## APPLICATION FOR SPECIAL USE PERMIT FOR GAS & FUEL SALES STATION

APPLICATION #: SUP26-0008  
APPLICANT: Hassan Hammami  
OWNER: Hassan Hammami, First Stop Properties LLC  
ADDRESS: 5303 W. Bancroft Street  
PARCEL(S): 20-24847  
ZONING: Regional Commercial (CR)  
NEIGHBORHOOD: Reynolds Corners  
REPORT DATE: May 1, 2026  
HEARING DATE: May 14, 2026  
STAFF REVIEWER: Karcher

<b>CENIC ARCHITECTURE</b> (419) 346-0289 WWW.CENICARCHITECTURE.COM License #001886 Expires On 12/31/2026		5303 W. BANCROFT STREET TOLEDO, OH 43615 SPECIAL USE PERMIT FOR FIRST STOP PROPERTIES
PROJECT NO.: 230026 DATE: 05/14/2026	DRAWN BY: JAC CHECKED BY: JAC PROJECT: 21	SHEET NO. <b>A2.0</b>

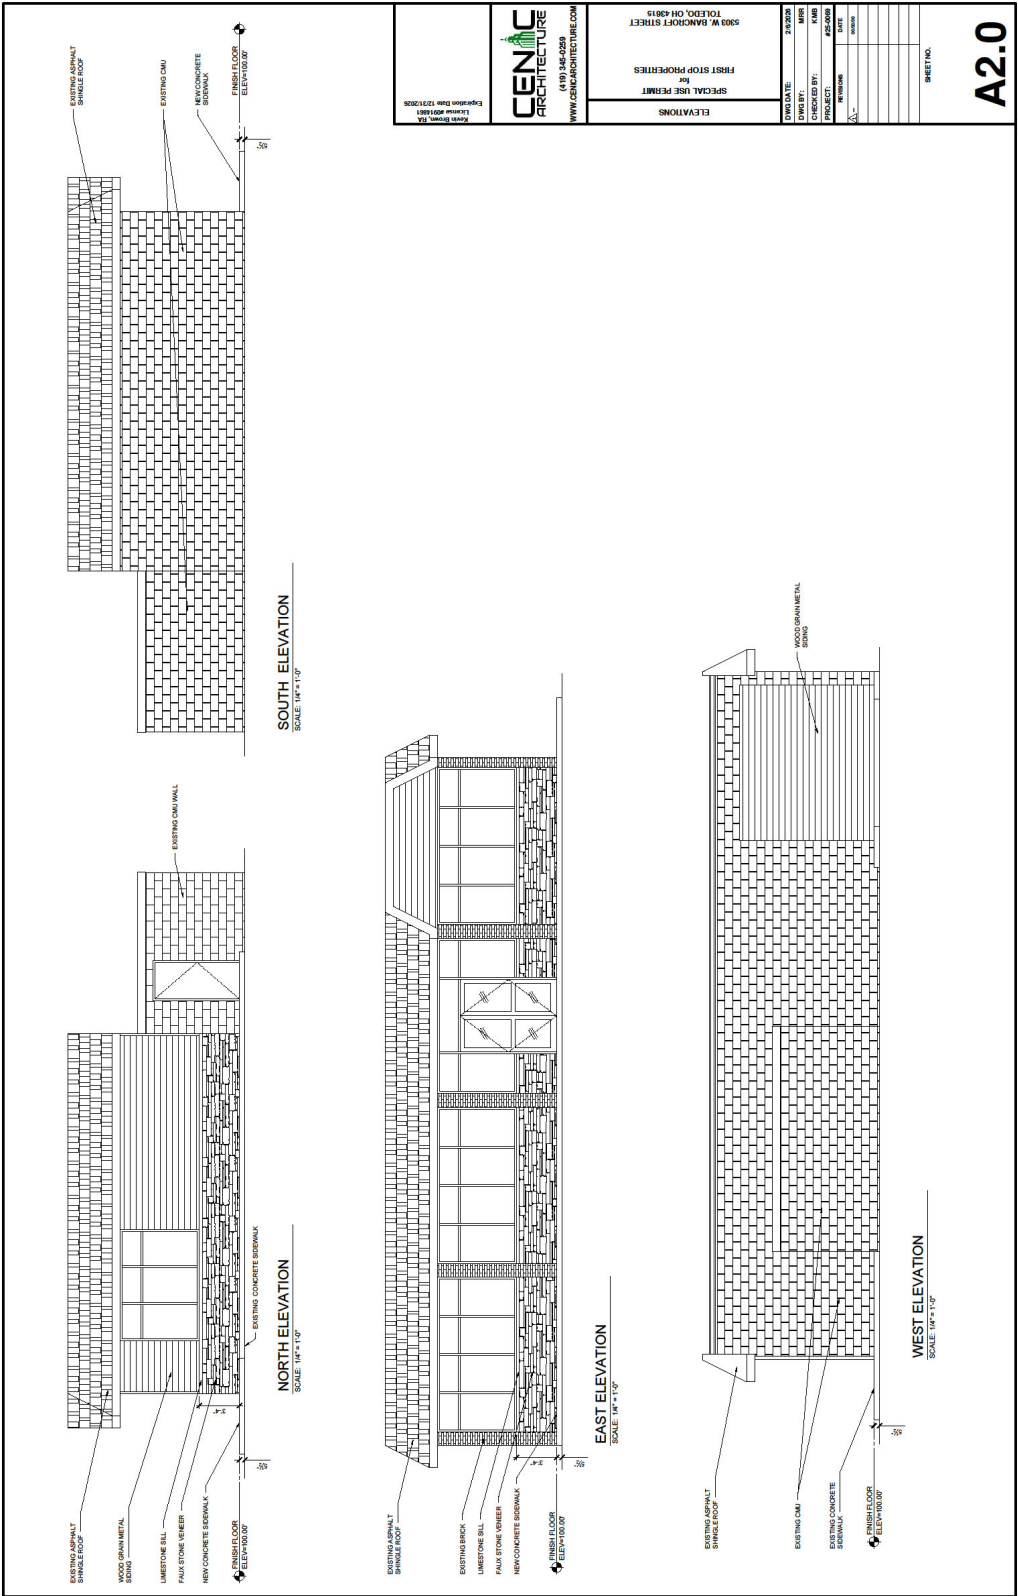
- (b) *Transparent Windows.* Transparent windows shall occupy at least forty percent (40%) of the area between two and ten feet for the primary elevation facing the right-of-way, and at least twenty percent (20%) for the elevation facing the side street. – Acceptable

- (c) *Building Façade Materials.* All building facades visible from the right-of-way must consist of at least eighty percent (80%) of predominant building materials and no more than twenty percent (20%) of accent materials. The north and east facades are proposed to be renovated. The east façade will consist of ninety-three percent (93%) predominant building materials including brick, cast stone and glass. The remaining seven percent (7%) building material is not identified on the plans. The north façade will consist of fifty-four percent (54%) of predominant building materials including cast stone and glass. The remaining four percent (4%) is noted as wood grain metal siding. This does not appear to meet material standards. Additional information shall be submitted to determine compliance, or another acceptable building material used. The south and west building facades are to remain unfinished concrete masonry units (CMU) with the exception of covering an existing overhead door on the west building elevation that will no longer be used. While unfinished CMU are not a permitted building material, they may remain since the building facades will not be significantly altered. The overhead door shall be covered with an acceptable building material. – Not acceptable

- (d) *Building Façade Colors.* Building colors shall be predominately subtle, neutral and earth-tone with no more than three (3) different accent colors. Building façade colors have not been determined.

29. Transparent windows shall occupy forty percent (40%) of the east and twenty percent (20%) of the north building elevations per TMC1109.0205(C.3). The required transparent windows are depicted on the building elevations.

30. All building facades must consist of at least eighty percent (80%) of predominant building materials and no more than twenty percent (20%) of accent materials per TMC§1109.0500 since they are all visible from a right-of-way.

- a. The east façade will consist of ninety-three percent (93%) predominant building materials including brick, cast stone and glass. The remaining seven percent (7%) building material is not identified on the plans. This building material shall be noted on the elevation plans and shall be a permitted building material.

- b. The north façade will consist of fifty-four percent (54%) of predominant building materials including cast stone and glass. The remaining forty-six percent (46%) is noted as wood grain metal siding. This material does not appear to meet material standards. Additional information shall be submitted to determine compliance, or another acceptable building material used.

- c. West and south facades will remain unfinished concrete masonry units (CMU) with the exception of covering an existing overhead door on the west building elevation that will no longer be used. While unfinished CMU are not a permitted building material, they may remain since the building facades will not be significantly altered. The overhead door shall be covered with an acceptable building material.

31. All building facades shall meet building color standards per TMC§1109.0500. Proposed colors for all building materials shall be noted on revised building elevations.
